NO.	DATE	DESCRIPTION	BY	APP.
1	6/1/06	pco#1, ch pole 3 and 6 to new	gd	bc

CONTRACT 31
TRAFFIC SIGNAL MODIFICATIONS
GOLDEN GATE AVE & SCOTT ST

SPECIFICATION NO.
0872J
DRAWING NO.
E-5.1
FILE NO.
86,421
REV. NO.
1

CONTRACT 31	SPECIFICATION NO. 0872J
TRAFFIC SIGNAL MODIFICATIONS	DRAWING NO. E-5.2
GOLDEN GATE AVE & SCOTT ST SCHEDULE	FILE NO. 86,422
	REV. NO. 0

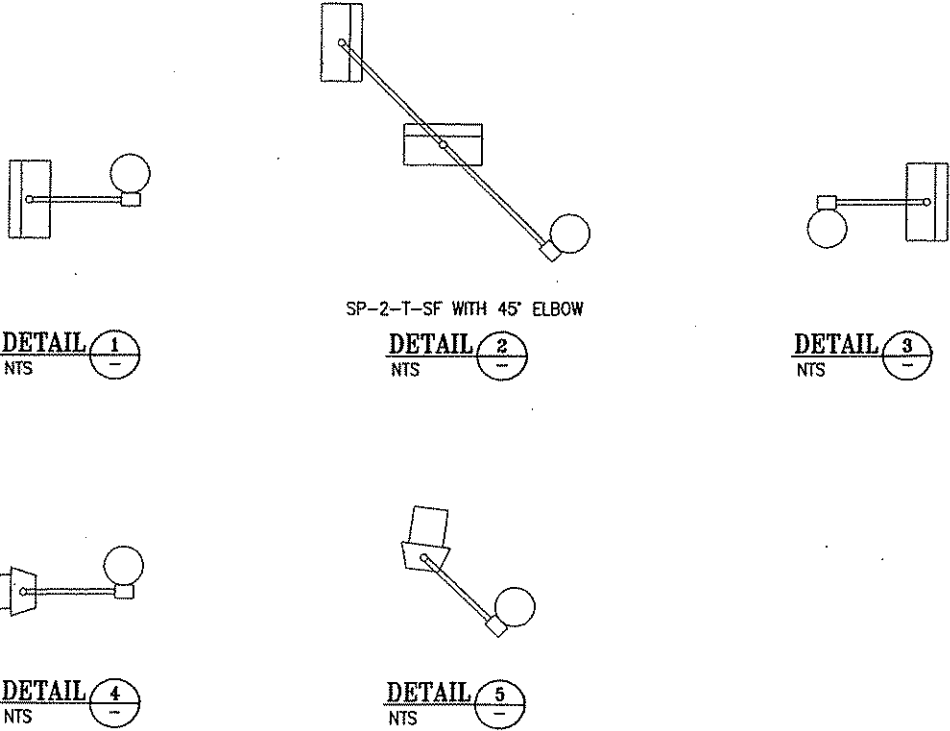
NO.	DATE	DESCRIPTION	BY	APP.
1	5/1/06	pco#1, ch pole 3 and 6 to new	gd	bc
